## Shift Link 3.0 Litre

MERCURY RACING 3.0L OUTBOARDS

Mercury Marine  
Mercury Racing Service Bulletin 2000-7  
W6250-9A Pioneer Road  
Fond du Lac, WI 54935

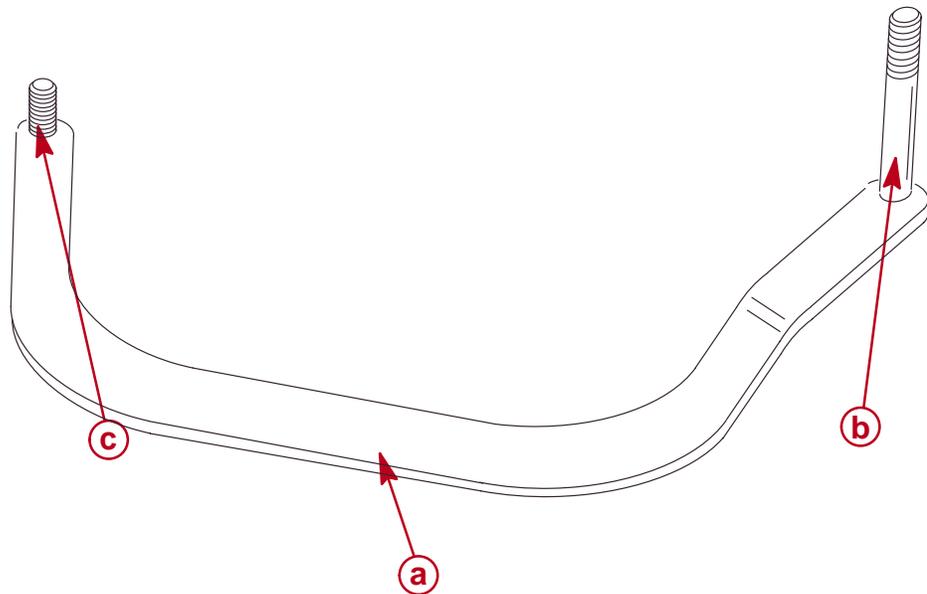
Some shift links may have insufficient weld penetration between the bracket and shift cable attaching stud. This could result in possible attaching stud breakage and loss of shift control.

- a** - Shift Link Bracket
- b** - Control Cable Attaching Stud
- c** - Shift Link to Upper Shift Shaft Attaching Stud

Affected outboards in dealer inventory **MUST** have the shift link replaced when being installed/rigged on boats, (See parts required).

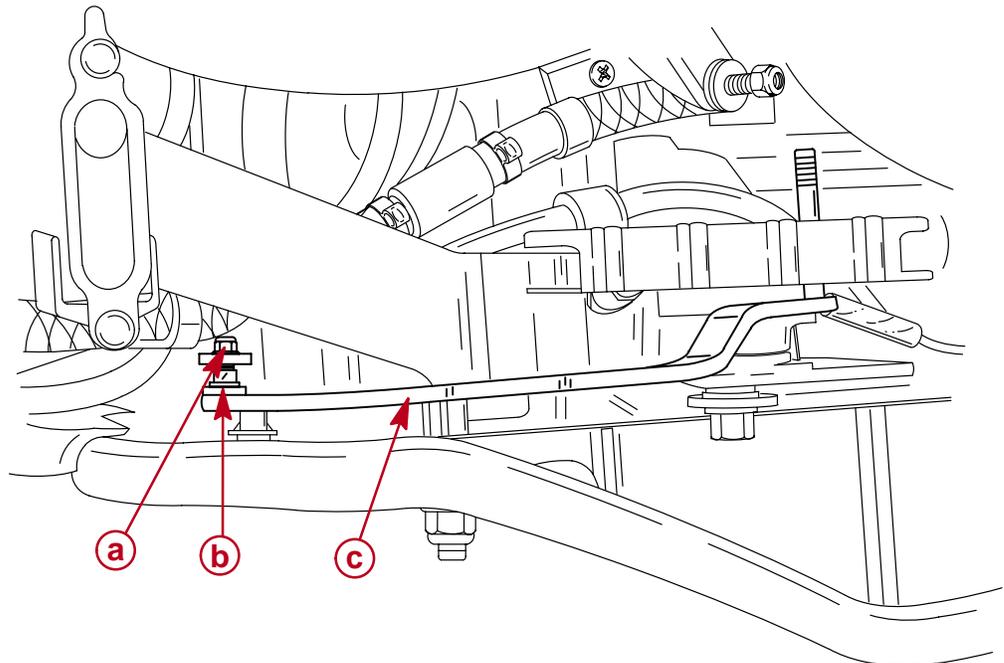
- Remove the nylock nut that attaches the shift link to the upper shift shaft, retain nylock nut and plastic bushing to be reused on the replacement shift link.

**NOTE:** The view below is shown with the front Nylock retainer nut loose and plastic bushing **NOT** engaged into the upper shift shaft.

- a** - Nylock Nut - Shift Link To Upper Shift Shaft
- b** - Plastic Bushing
- c** - Shift Link Assemble

- Install shift link into upper shift shaft, taking care that plastic bushing enters the shift shaft correctly. Install the nylock nut and drive tight.
- Reinstall shift roller, shift cable, washer, and nylock nut.
- Reinstall top cowl.
